**Alternative roof terrace balustrading:**

**SK01 . alternative roof terrace balustrade** . date: 21.04.10 . 44 new road . shoreham by sea . Mr. & Mrs. Jenkins

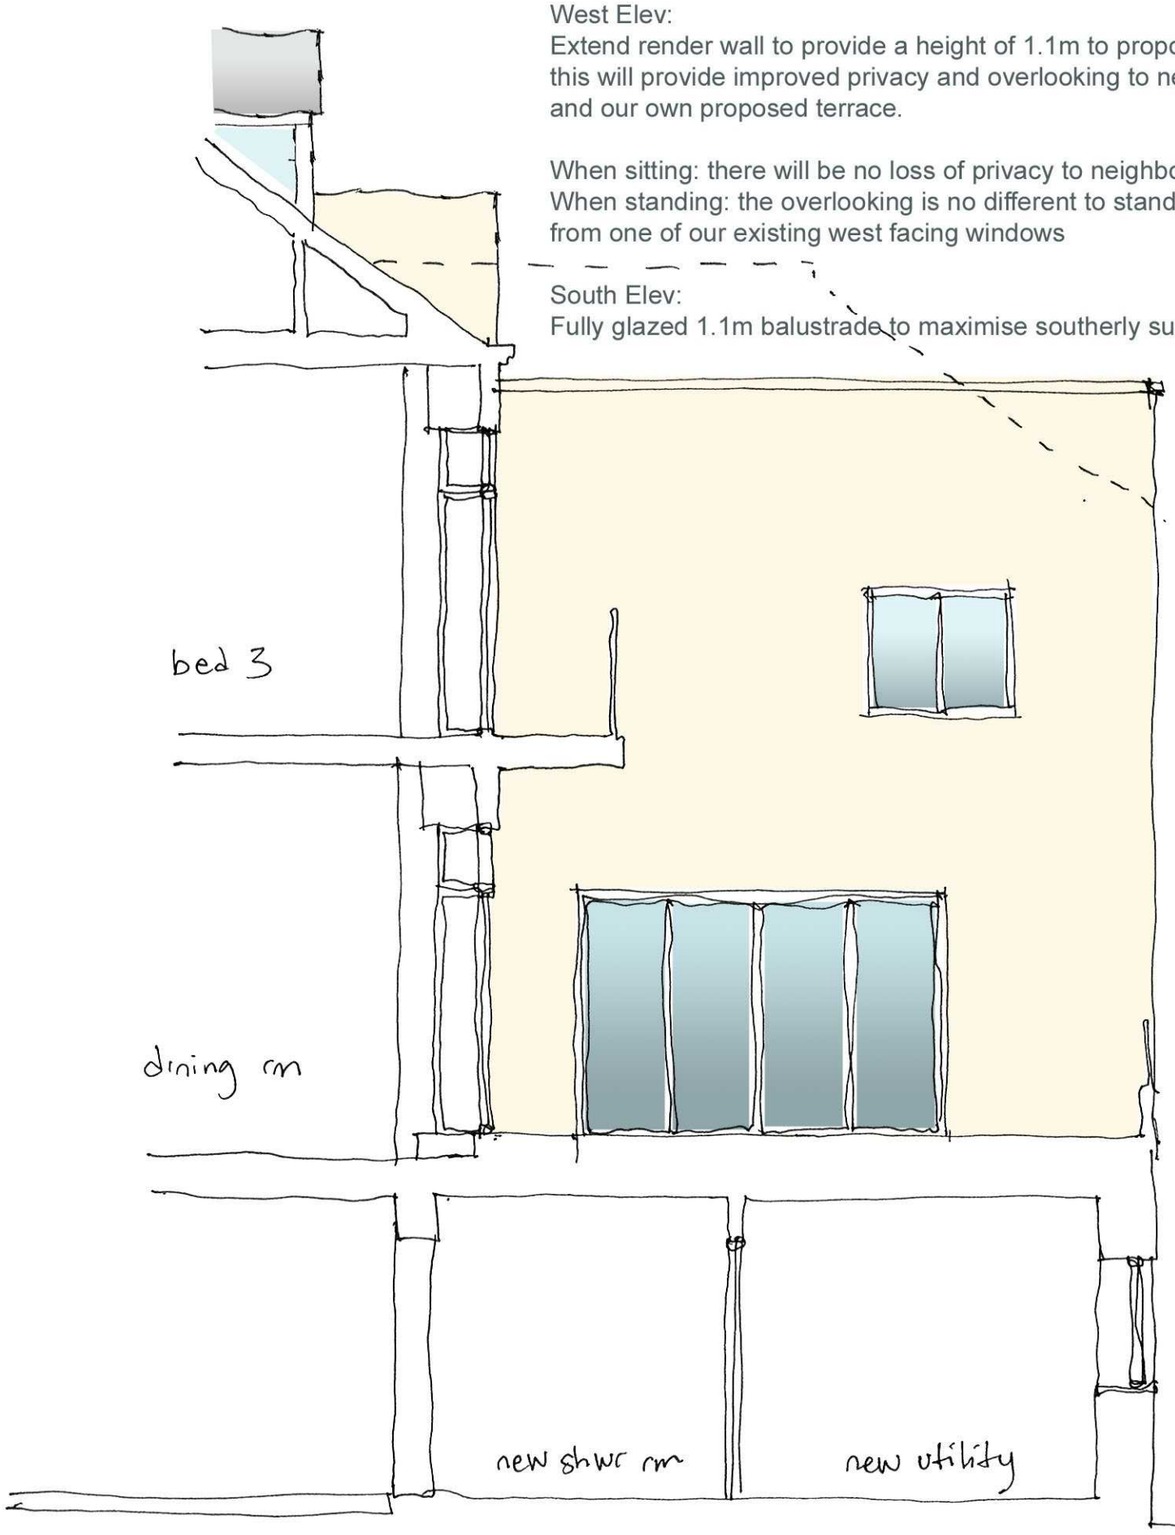
West Elev:
Extend render wall to provide a height of 1.1m to proposed roof terrace, this will provide improved privacy and overlooking to neighbouring property and our own proposed terrace.

When sitting: there will be no loss of privacy to neighbours what so ever.
When standing: the overlooking is no different to standing and looking out from one of our existing west facing windows

South Elev:
Fully glazed 1.1m balustrade to maximise southerly sun and views.
